#### ADDENDUM NO. 01

#### TO: PLANS AND SPECIFICATIONS FOR STATE OF MISSOURI

Replace Chiller & Fan Coil Units Oakview State School Monett, Missouri PROJECT NO.: E2331-01

**MECHANICAL** PIPING PLAN

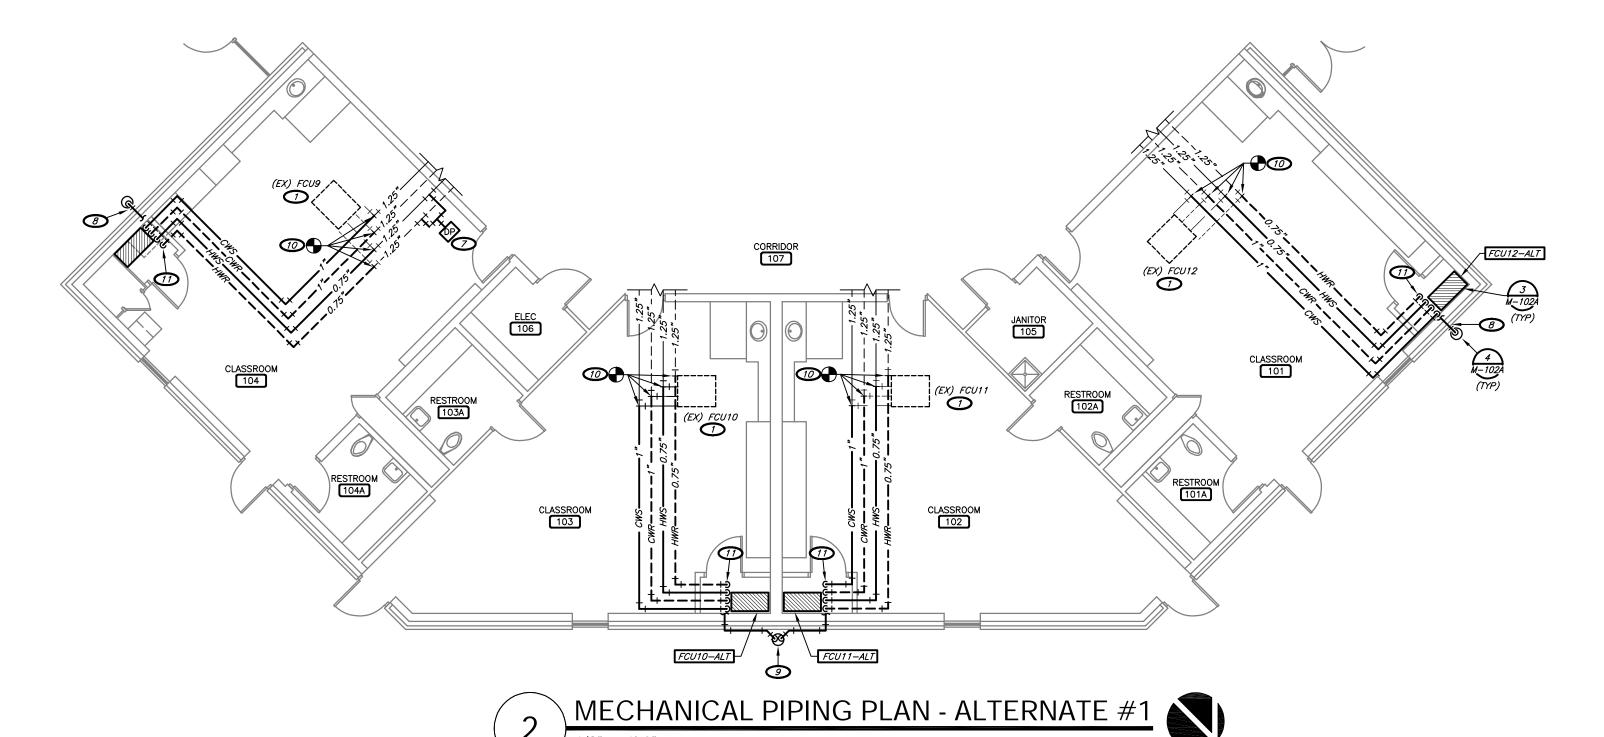
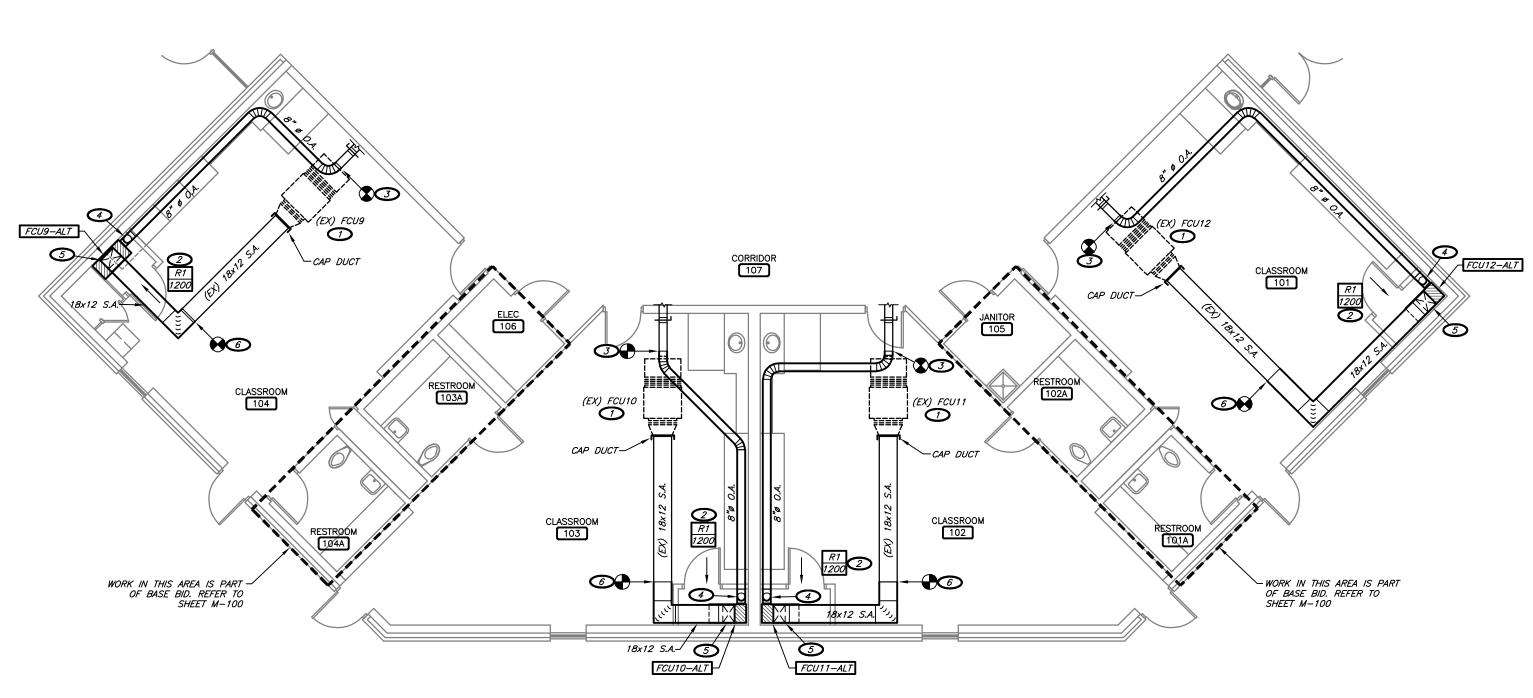
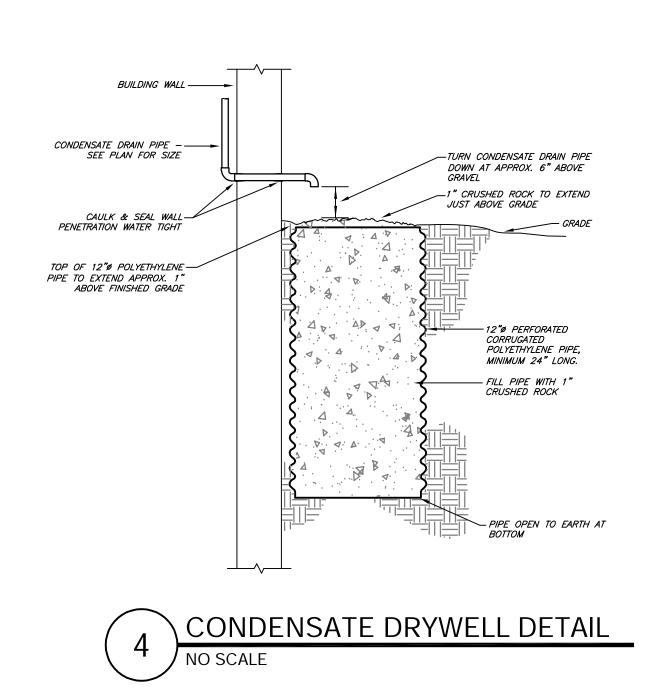
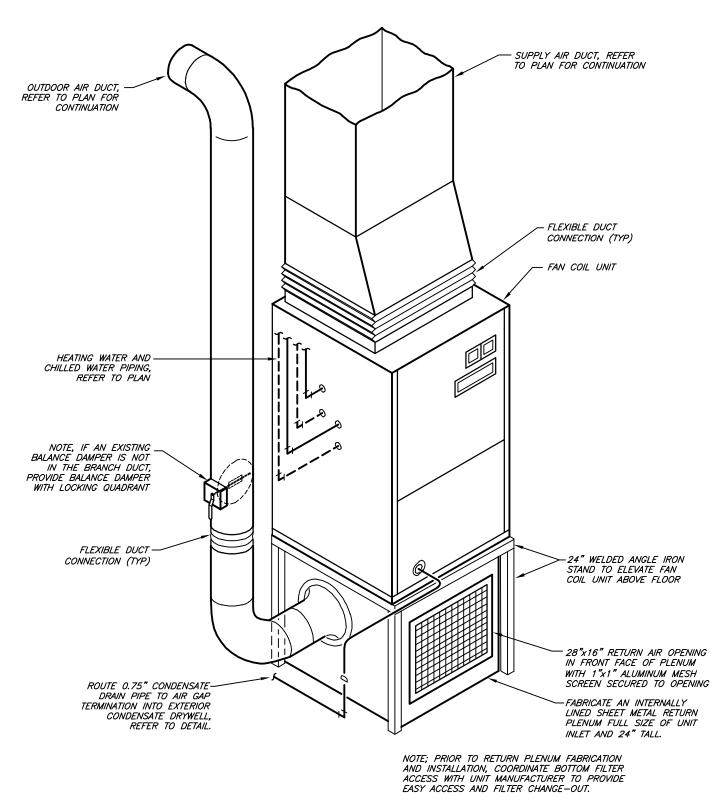
- 1. Sheet M-101 See Attached revised sheet M-101
  - a. ADD alternate #2 Special Notes.
  - b. DELETE three-way valves at DOAS units on Mechanical Piping Plan.

- b. Should the DOAS coil valves be 3-way (as shown on page M101) or 2-way (as shown on M500)? During the meeting, you indicated to follow detail 3 on M500 (2-way).

- i. These valves should be two-way as shown on M-500.

**MECHANICAL** PLANS -**ALTERNATE #1**

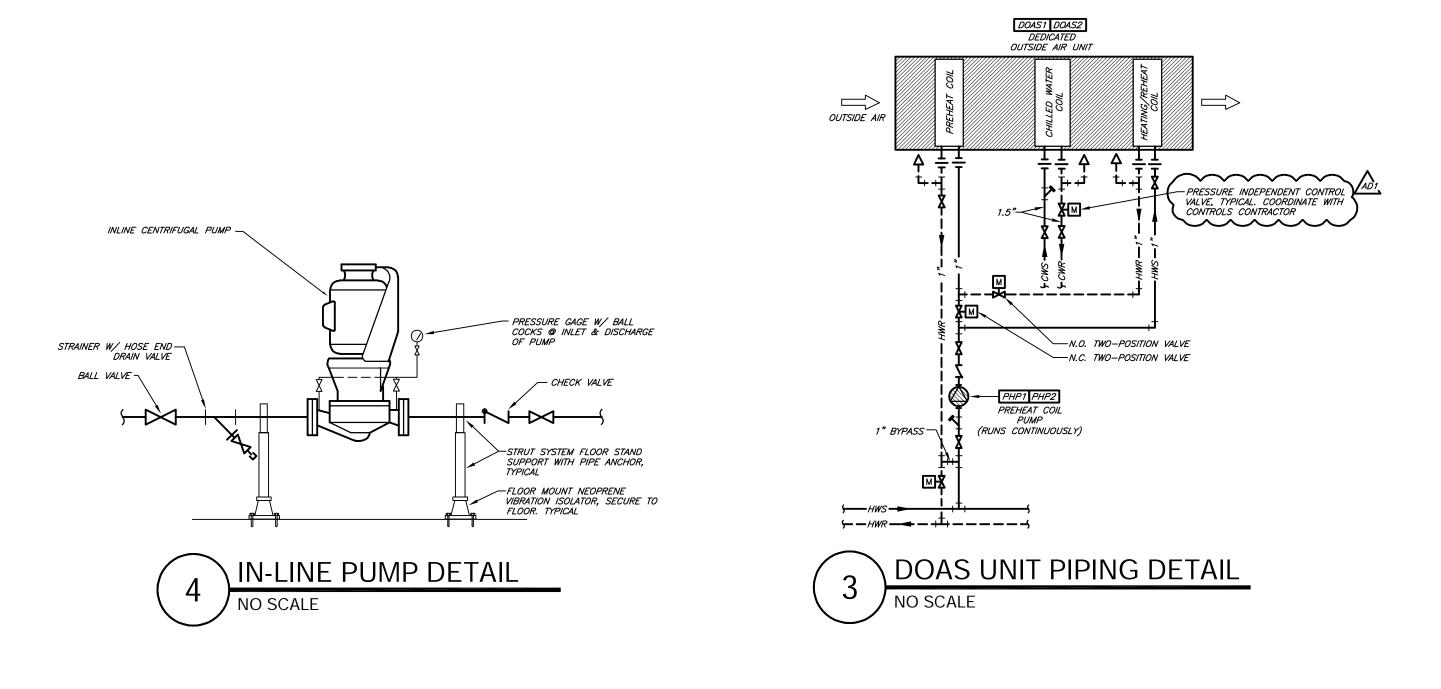
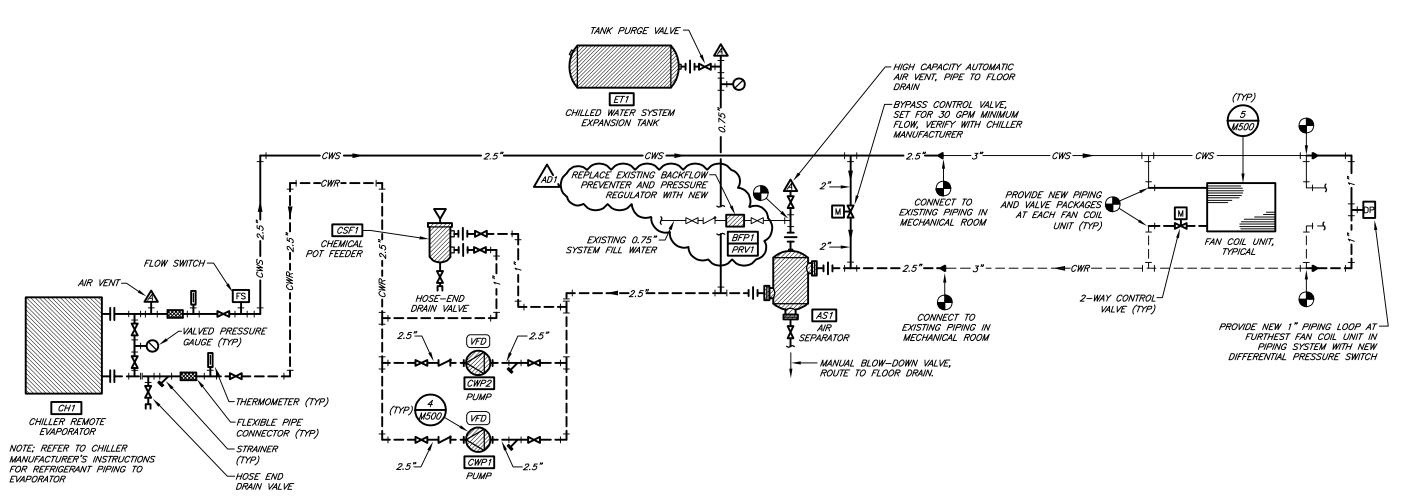
- 2. Sheet M-102A See Attached revised sheet M-102A
  - a. ADD alternate #2 Special Notes.
- 3. Sheet M-500 See Attached revised sheet M-500
  - a. Detail #1 and #2: ADD backflow preventer and pressure reducing valve note to Heating Water and Chilled Water Piping Diagrams.
  - b. Detail #3: ADD control valve note to DOAS Unit Piping Detail.
- 4. Sheet M-600 See Attached revised sheet M-600
  - a. ADD backflow preventer and pressure reducing valve sections to Hydronic Specialties Schedule.

### **ALTERNATE #2 SPECIAL NOTES:**

ALTERNATE #2: CONTRACTOR SHALL REMOVE ALL EXISTING PIPING INSULATION FROM EXISTING HEATING HOT WATER, CHILLED WATER, CONDENSATE, AND REFRIGERANT PIPING, AND REPLACE WITH NEW INSULATION PER THE SPECIFICATIONS.

MECHANICAL DETAILS

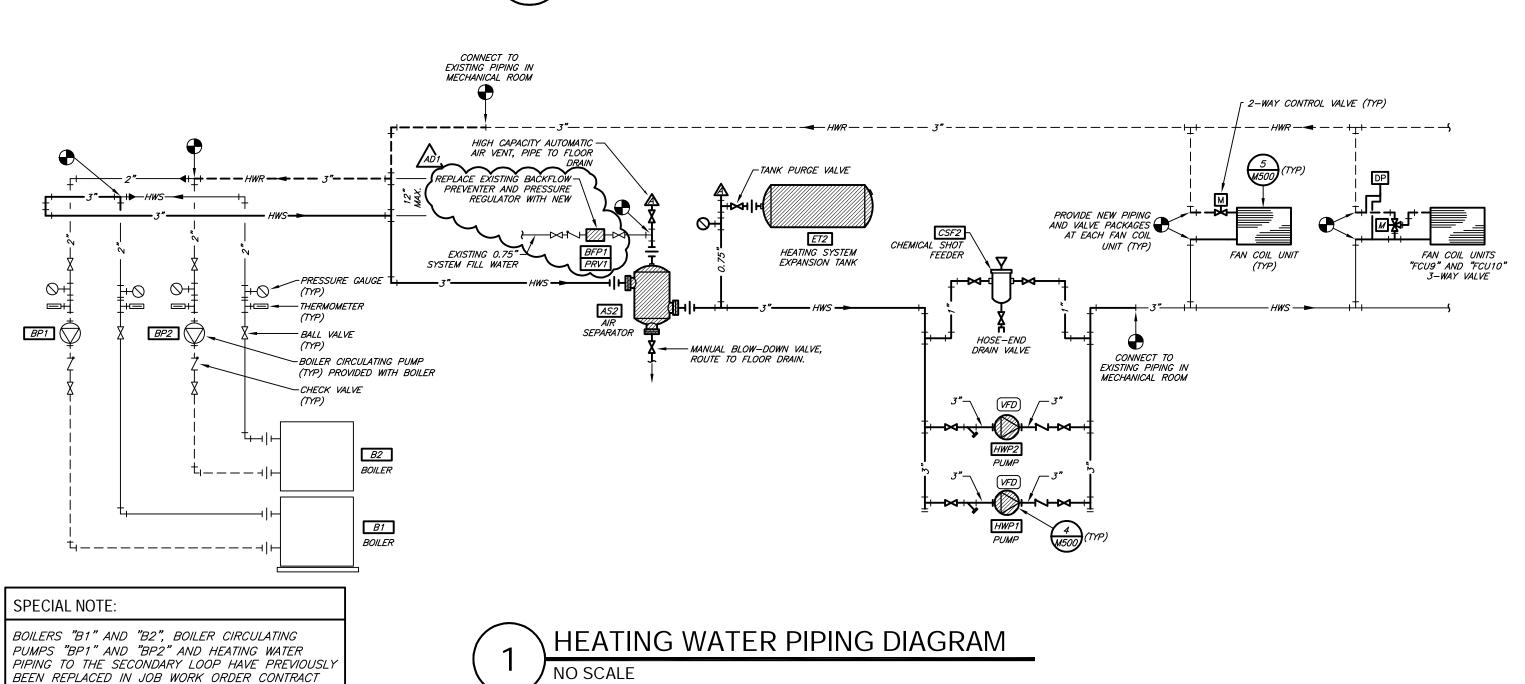
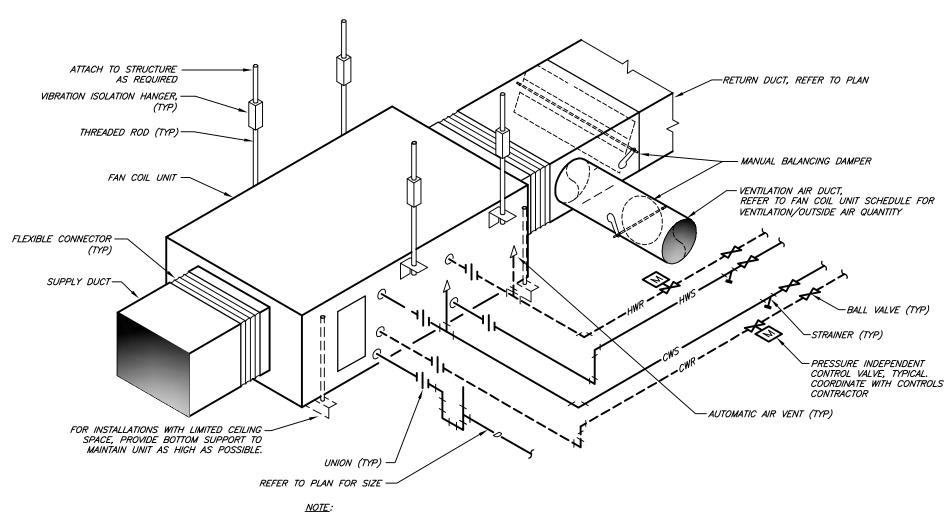
- c. Are we supposed to use pressure independent control valves for the chilled water on the Fan coil units (Detail 5, M500) only or are pressure independent control valves required for the hot water as well?

- i. Pressure independent control valves shall be used for control valves on heating hot water as well.
- d. The sequences on page M-501 indicate that the chiller controls (and boiler controls) are to provide the control of the chilled water (and hot water system). Should we plan for the chiller and boiler to do that control directly or should the building automation system controllers provide direct control of those systems?
